PROPOSED RESIDENTIAL APARTMENT COMPLEX 3-STORY

FREEDOM SPRINGS
734 WESTERN DRIVE
COLORADO SPRINGS, EL PASO COUNTY,
COLORADO 80915

SITE DEVELOPMENT PLAN
SDP

Landscape Plan
LS1

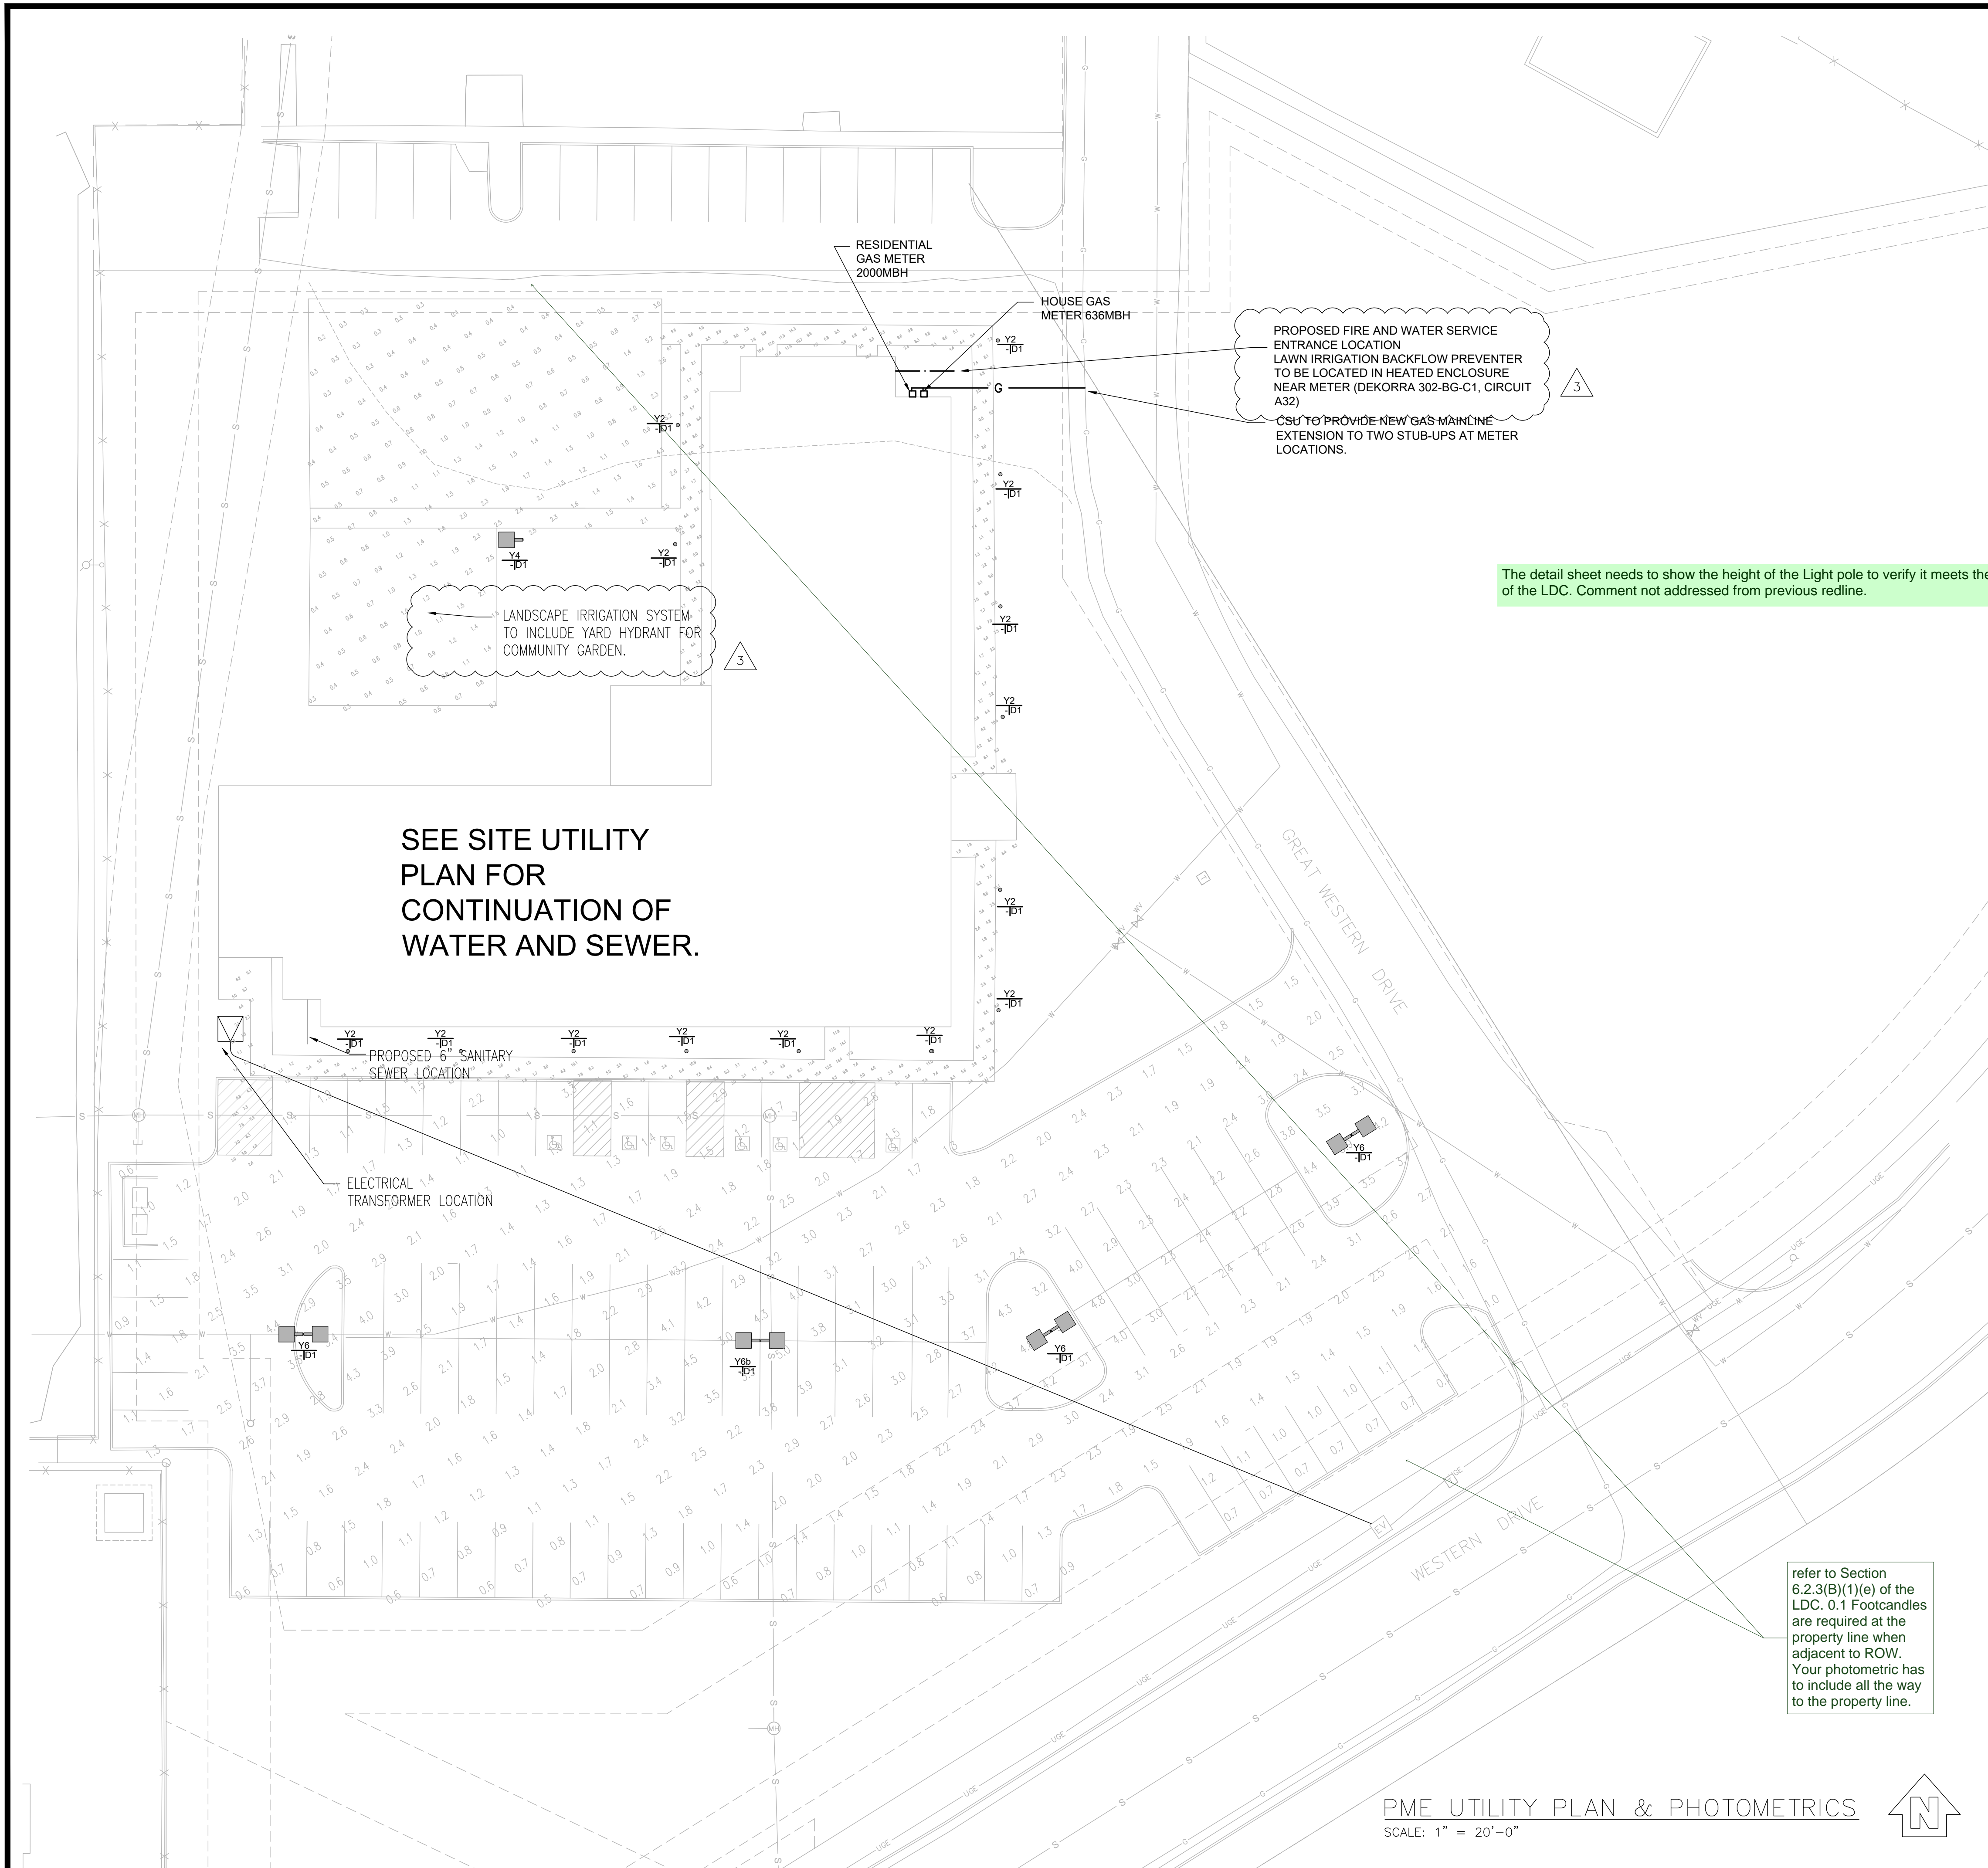
ADDENDUM #3
 Landscape layout revised to reflect addition of public sidewalk from building to street. Planting bed configurations have been revised, but all plant material and landscape boulder quantities have remained unchanged.

LIGHT POLE BASE DETAIL (WALK ADJACENT) 1
NOT TO SCALE RME100

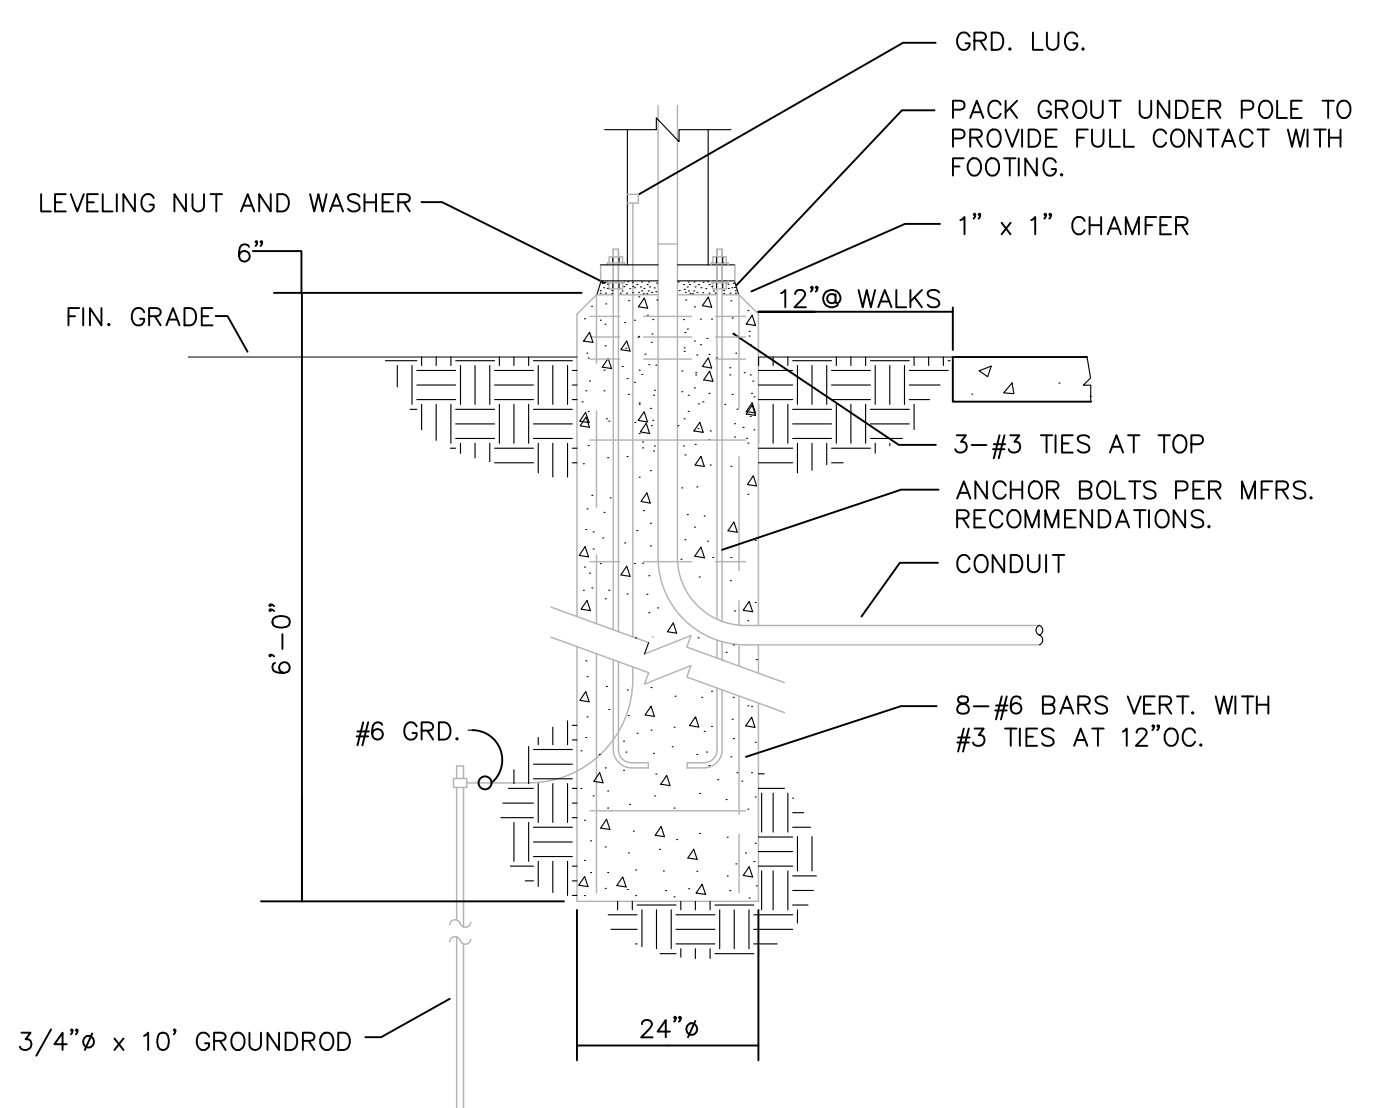
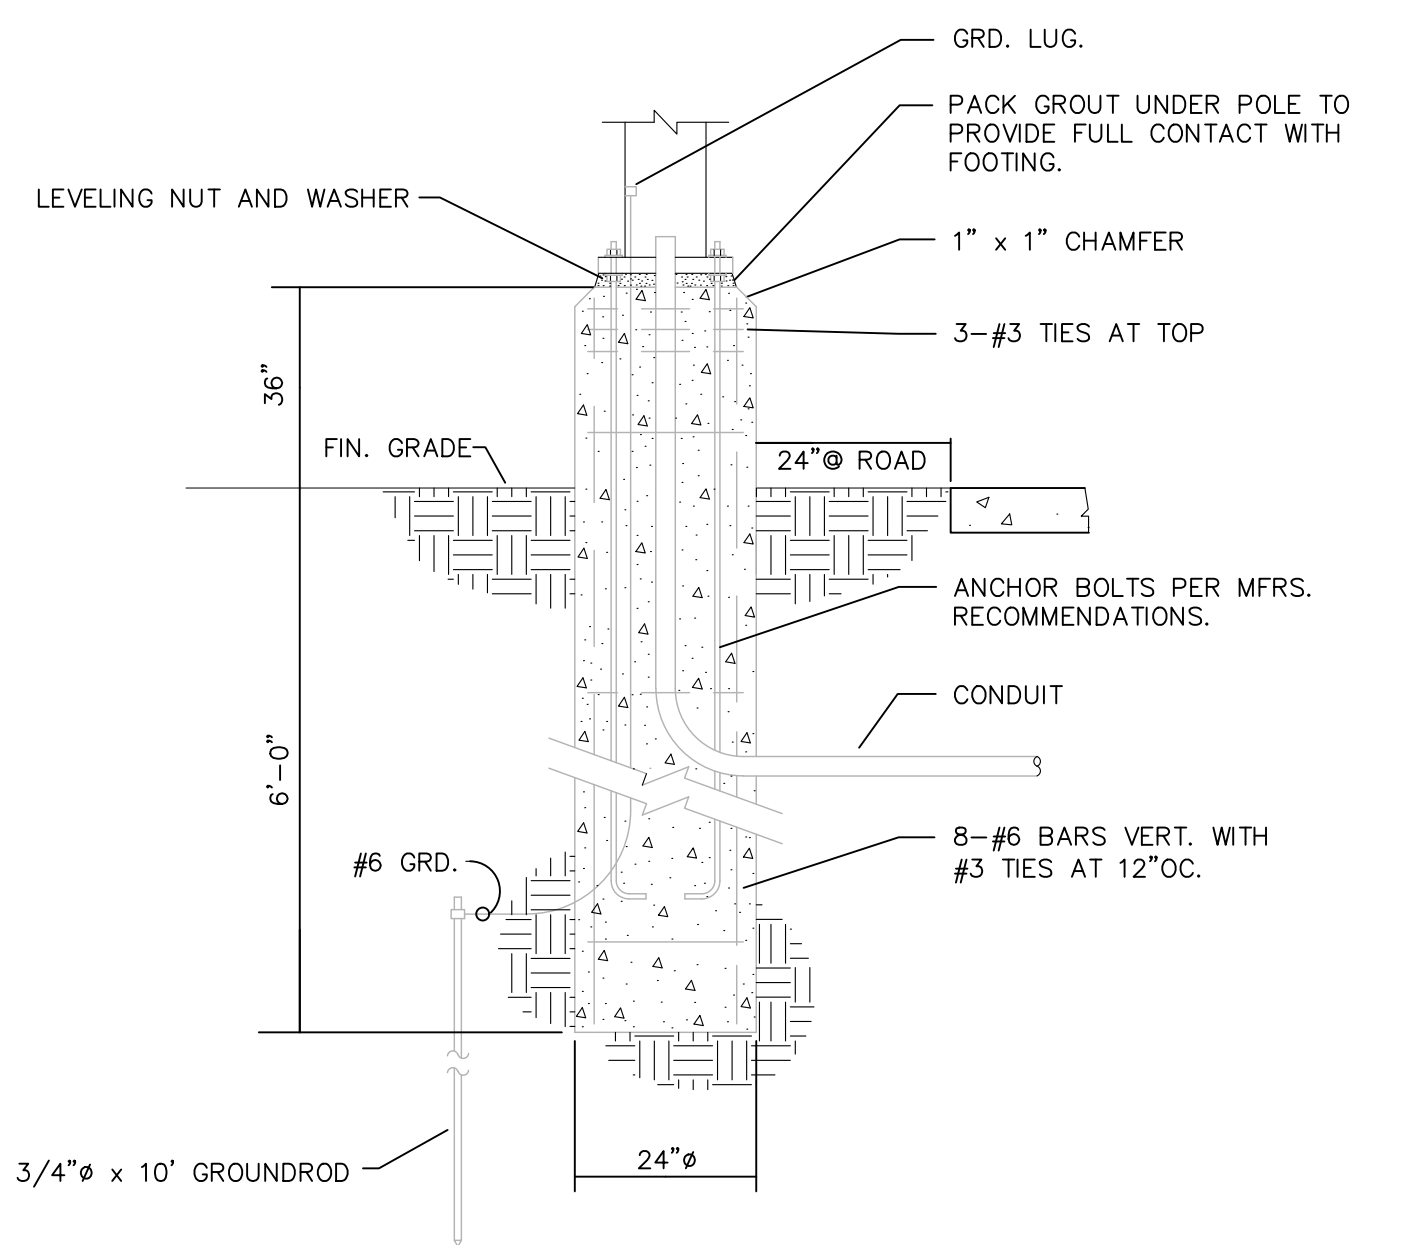
The detail sheet needs to show the height of the Light pole to verify it meets the standard of the LDC. Comment not addressed from previous redline.

refer to Section 6.2.3(B)(1)(e) of the LDC. 0.1 Footcandles are required at the property line when adjacent to ROW. Your photometric has to include all the way to the property line.

SIGNAGE
G-010

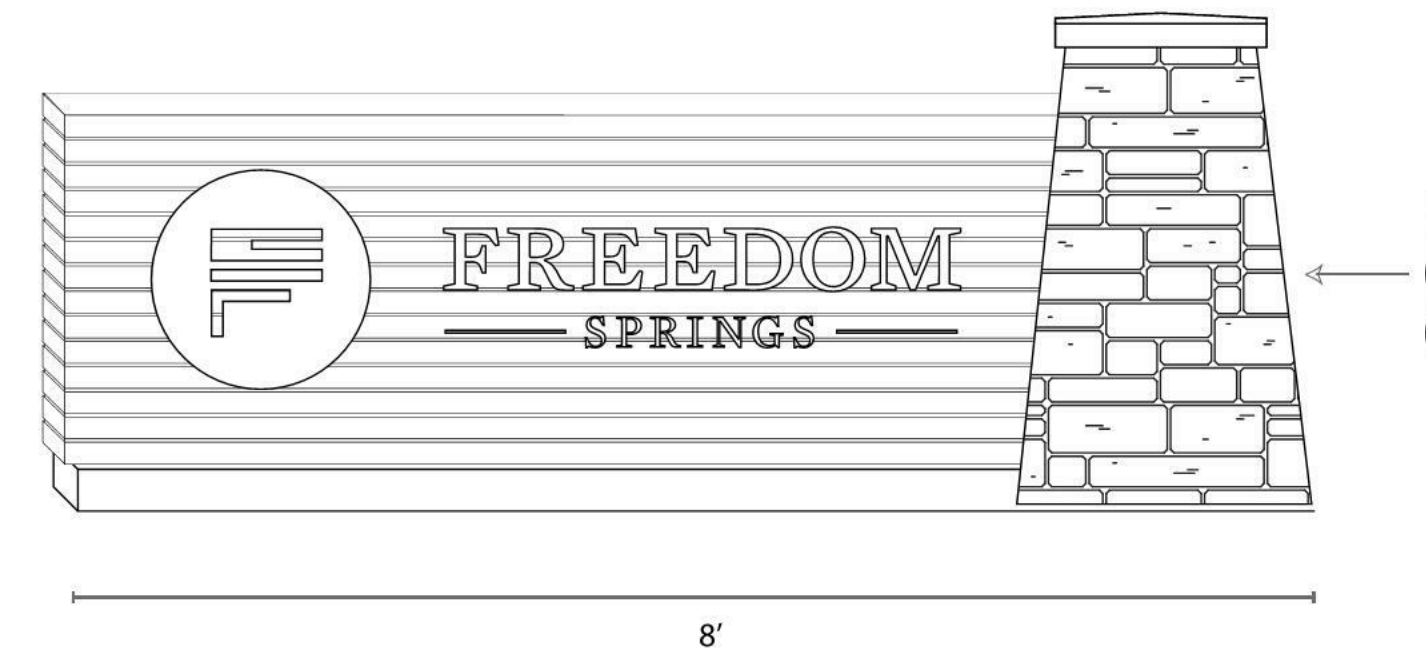
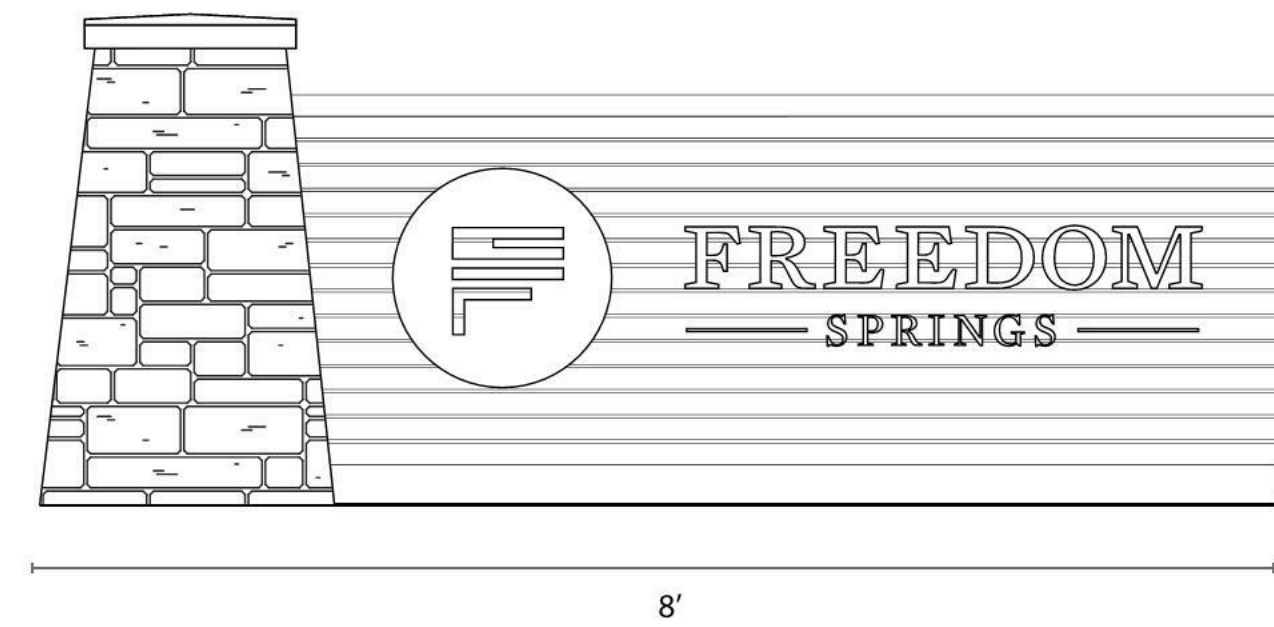
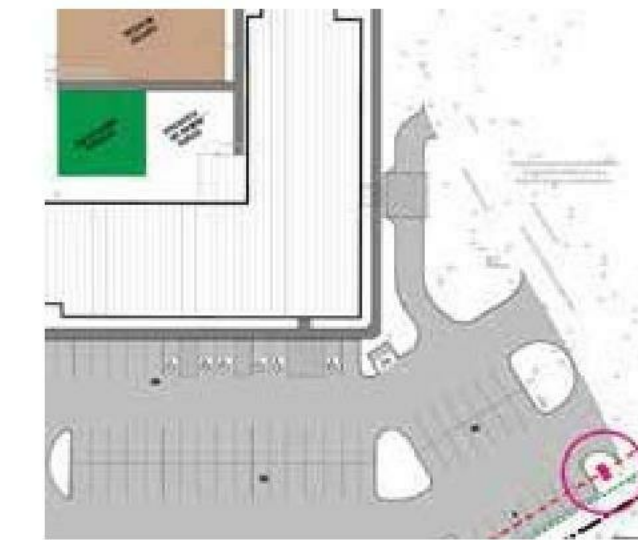
Sign plan must be submitted on EDARP on additional project, this has not been done.
